Item Name: Replacement Exterior Window For -111

DRAWING NO. D3290	TITLE REPLACEMENT WINDOW ASSEMBLY	REV. C	DART AEROSPACE LTD ENGINEERING ORDER		D.E.O. NO. D3290-C-1	SHEET NO. SHEET 1 OF 1	SCALE NTS
DRAWN <i>gp</i>	CHECKED <i>js</i>	MFG. APPR. <i>EZ</i>	APPROVED <i>MD</i>		DE APPR. <i>##</i>		
DATE 09.09.18	DATE 09.09.18	DATE 09.09.18	DATE 09/08/21		DATE 09/09/21

PURPOSE:

CHANGE MATERIAL THICKNESS OF D3290-1 FRAME TO 0.063 FROM 0.040. REF PAR 09-033.

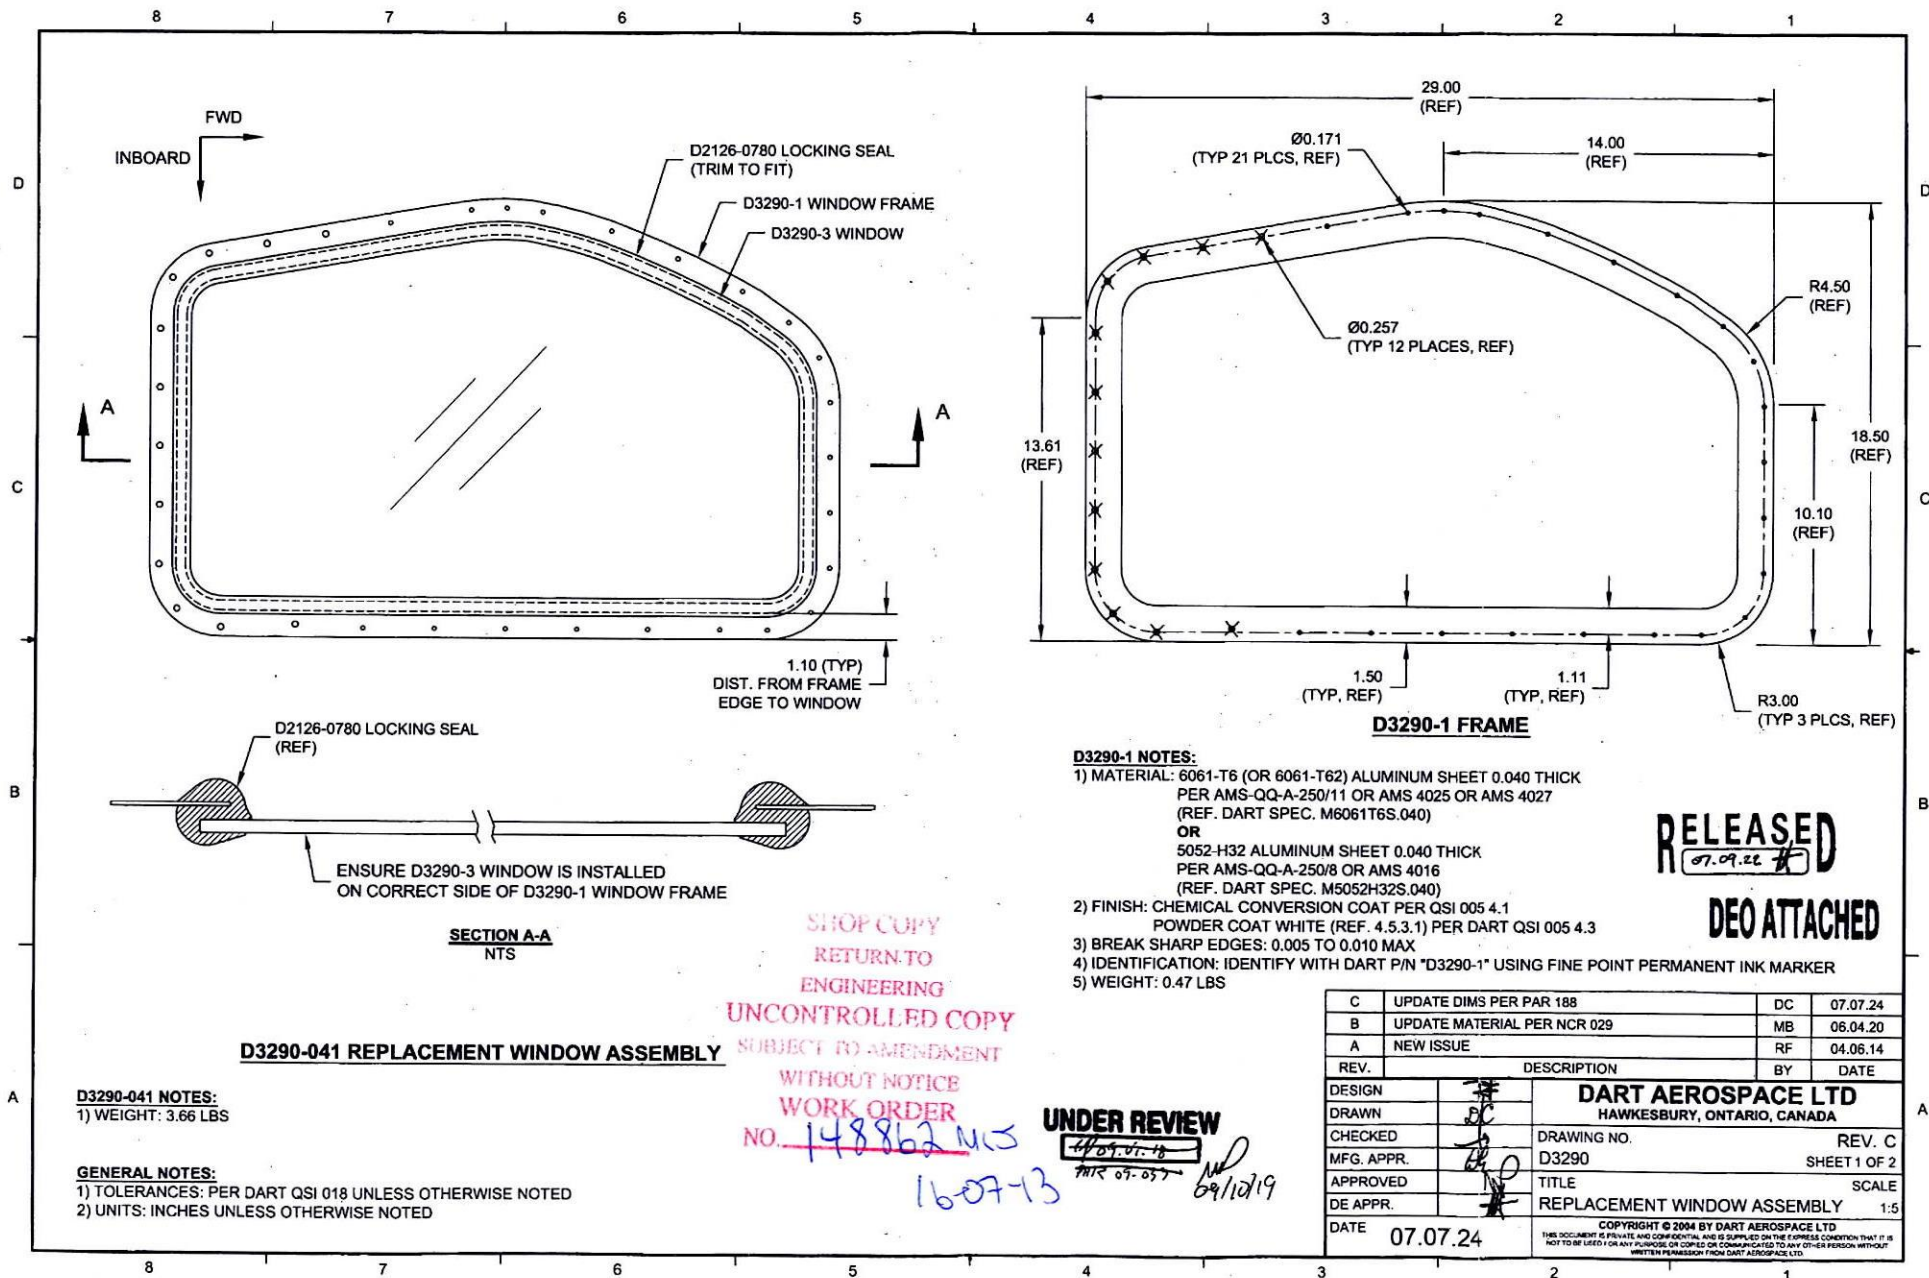
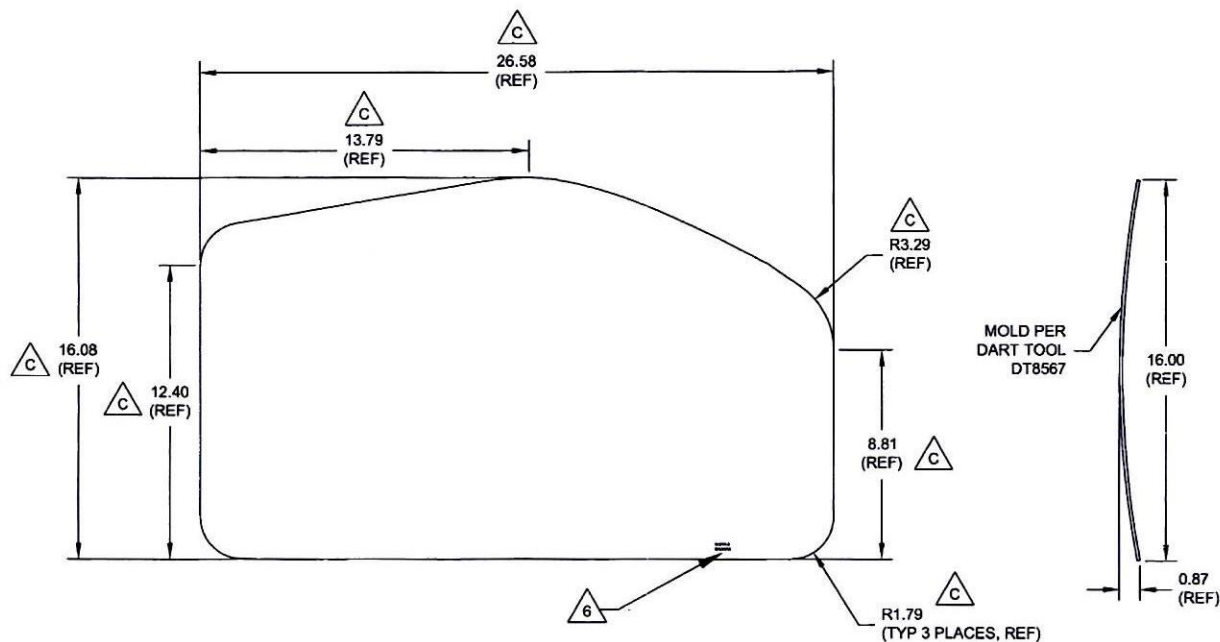
MATERIAL CALL-OUT OF D3290-1 FRAME ON SHEET 1 IS AMENDED AS FOLLOWS:

- 1) MATERIAL: 6061-T6 (OR 6061-T62) ALUMINUM SHEET ~~0.040 THICK~~ 0.063 THICK (REPLACE)
 PER AMS-QQ-A-250/11 OR AMS 4025 OR AMS 4027
~~(REF. DART SPEC. M6061T6S.040)~~ REF. DART SPEC. M6061T6S.063 (REPLACE)
 OR
 5052-H32 ALUMINUM SHEET ~~0.040 THICK~~ 0.063 THICK (REPLACE)
 PER AMS-QQ-A-250/8 OR AMS 4016
~~(REF. DART SPEC. M5052H32S.040)~~ REF. DART SPEC. M5052H32S.063 (REPLACE)
